NO.	DATE	REVISION
1	03/09/20	30% SFE SUBMITTAL
2		
3		
4		
5

HARMONY
8550 164TH AVE NE
 WASHINGTON
 REDMOND

TITLE: **UTILITY PLAN**
 SHEET: **C-1**

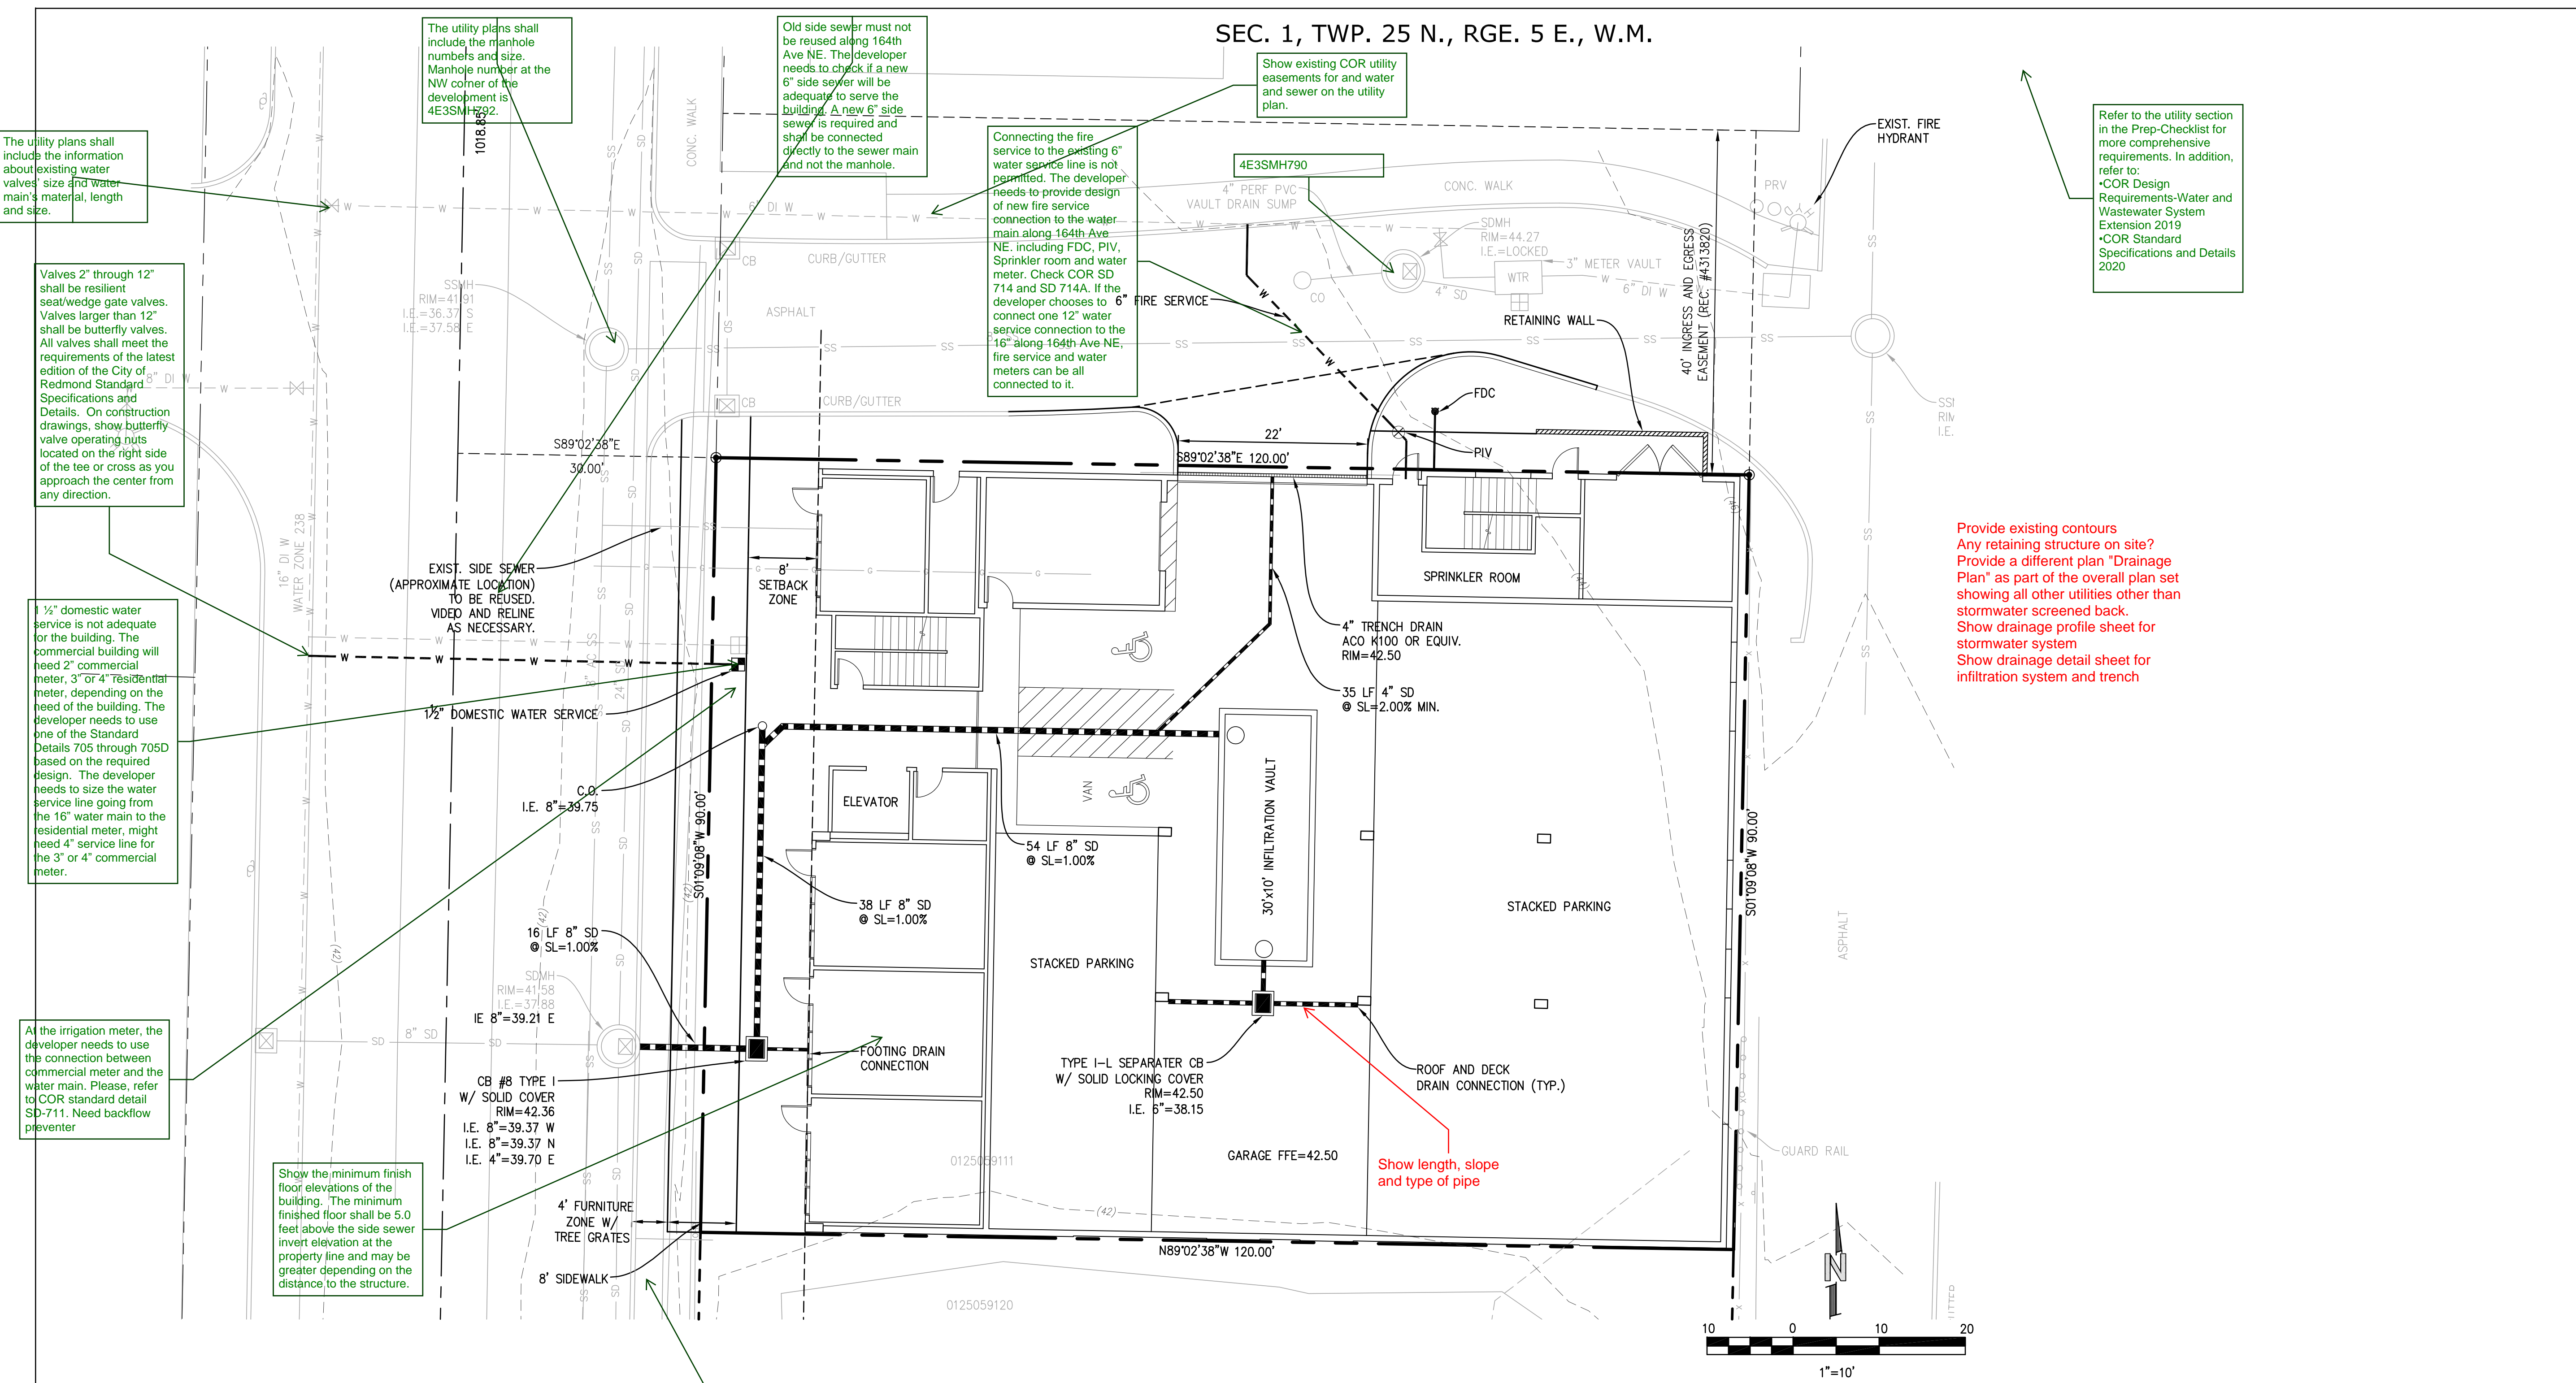
The utility plans shall include the information about existing water valves' size and water main's material, length and size.

The utility plans shall include the manhole numbers and size. Manhole number at the NW corner of the development is 4E3SMH792.

Old side sewer must not be reused along 164th Ave NE. The developer needs to check if a new 6\"/>

Show existing COR utility easements for and water and sewer on the utility plan.

Connecting the fire service to the existing 6\"/>

Valves 2\"/>

1/2\"/>

All the irrigation meter, the developer needs to use the connection between commercial meter and the water main. Please, refer to COR standard detail SD-711. Need backflow preventer

Show the minimum finish floor elevations of the building. The minimum finished floor shall be 5.0 feet above the side sewer invert elevation at the property line and may be greater depending on the distance to the structure.

Provide existing contours
 Any retaining structure on site?
 Provide a different plan "Drainage Plan" as part of the overall plan set showing all other utilities other than stormwater screened back.
 Show drainage profile sheet for stormwater system
 Show drainage detail sheet for infiltration system and trench

Proposed trees shall be within 8 feet of new or existing water and sewer mains.

See comments on IL01 Existing Illumination page for streetlight conduit and pull box requirements
